Intersection ID: 18794	Main Street: RANDOLPH_RD	Cross Street: REMBRANDT_CR	Location:	SW
ADA ID: 3118731EC6E3	Ramp Type: PerpDiag	Initial Pass/Fail: Fail	Overall Compliance: No	Severity Score: 58.75

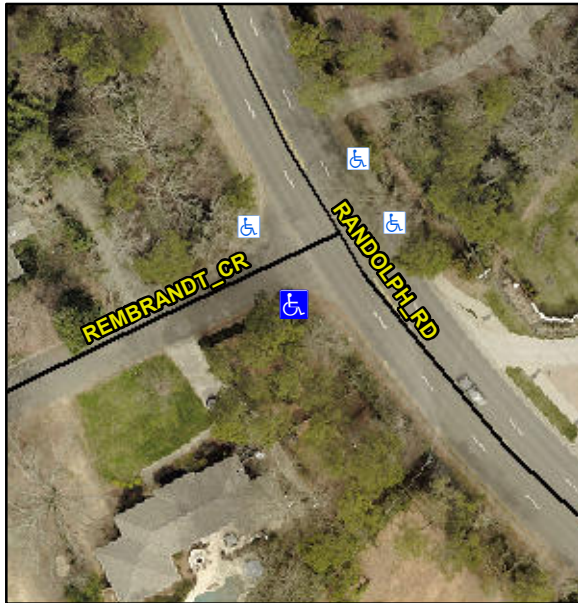
**Not Found, R304.5.1, R304.2.2,
R304.5.3**

Compliance	Description	Data	Compliance	Description	Data
N/A	Ramp Length (in)	56.0	No	Ramp Slope (%)	16.2
No	Ramp Width (in)	47.0	No	Ramp XSlope (%)	10.3
N/A	Flare Type LT	N/A	N/A	Flare Type RT	N/A
N/A	Flare Slope LT (%)	N/A	N/A	Flare Slope RT (%)	N/A
N/A	Flare Traversable LT?	N/A	N/A	Flare Traversable RT?	N/A
N/A	Landing Length (in)	N/A	N/A	DWS Provided?	N/A
N/A	Landing Width (in)	N/A	N/A	DWS Contrast?	N/A
N/A	Landing Slope (%)	N/A	N/A	DWS Length (in)	N/A
N/A	Landing X Slope (%)	N/A	N/A	DWS Full Width?	N/A
N/A	Landing Curb? (Y/N)	N/A	N/A	DWS Offset (in)	N/A
N/A	Shared Landing?	N/A			
N/A	Gutter Ponding?	N/A	N/A	Gutter Slope (%)	N/A
N/A	Gutter Lip Ht (in)	N/A	N/A	Gutter X Slope (%)	N/A
N/A	Painted X Walk1?	No	N/A	Painted X Walk2?	No
	X Walk 1 Direction	To E		X Walk 2 Direction	To N
N/A	X Walk 1 Width (in)	N/A	N/A	X Walk 2 Width (in)	N/A
	X Walk 1 Slope (%)	7.6		X Walk 2 Slope (%)	3.9
	X Walk 1 X Slope (%)	2.5		X Walk 2 X Slope (%)	0.2

Remove & Replace Curb Ramp With Two New Directional Ramps or Equivalent.
